State of Washington
DEPARTMENT OF FISH AND WILDLIFE

Amy Moon
Washington Energy Facility Site Evaluation Council
621 Woodland Square Loop SE
PO Box 43172
Olympia, WA 98504-3172
Subject: Draft Environmental Impact State: Horse Heaven Hills Wind/Solar/Battery Storage

Hot Pink = project area; Green Diamonds = 244 wind turbines, Orange = solar; Yellow Diamonds = Historic (and active $n = 2$) FEHA nests that represent 16 territories; Red Circles = an example of active nest core areas ($r = 2$)

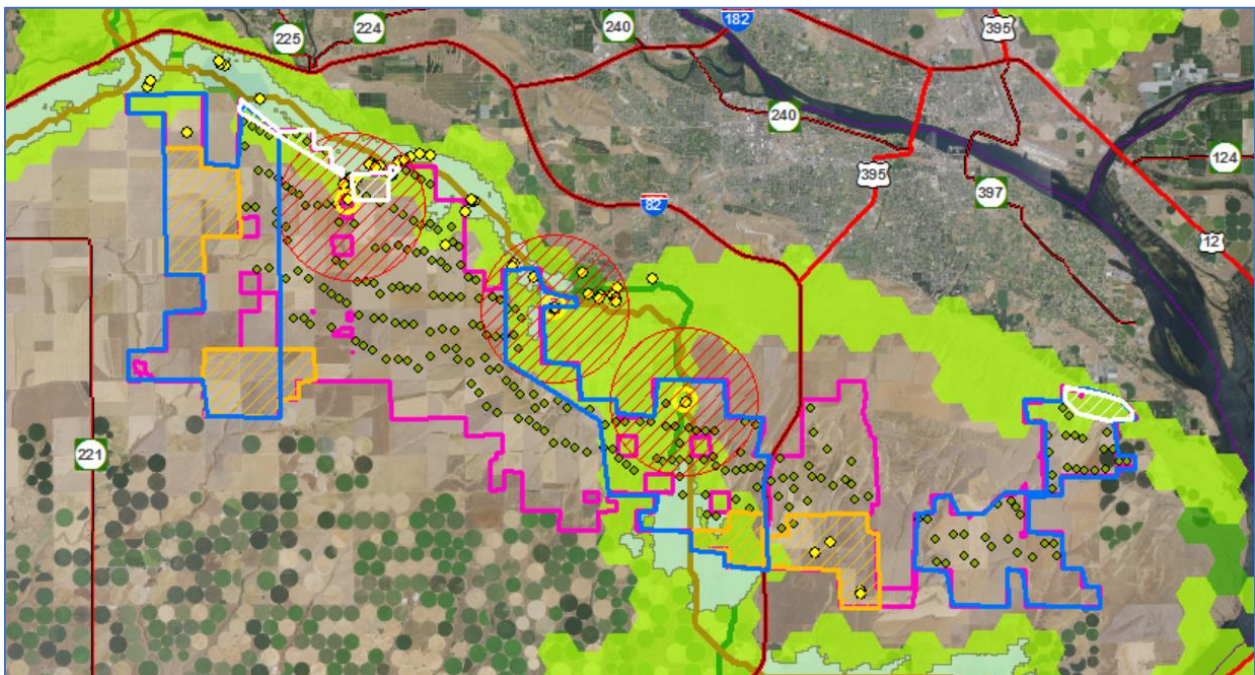
Then in February 2022, we shared with EFSEC that, “...there are 4 FEHA core area exclusion zones -from West to East - Webber, Badger, Sheep, and the eastern one, which is in the area of the Coyote Canyon FEHA nesting territory. Based on research, these core areas are where FEHA use is the highest but does not include the entire home ranges, so FEHA will still be exposed to turbines outside of these areas. Additionally, there are two turbines to the north just outside of the Webber exclusion zone that we also discussed with you that should also be excluded.” Additionally, we pointed out that two FEHA nesting territories (Beck Road and 4-mile) are both within the eastern solar development area just to the east of Highway 395.

Also in February 2022, we met with EFSEC and the applicant and provided the figure below and justification for recommending the central blue polygon as mitigation, offered ideas for project infrastructure and operations and vegetation management within the mitigation area, and identified turbine exclusion zones within the red FEHA circles.
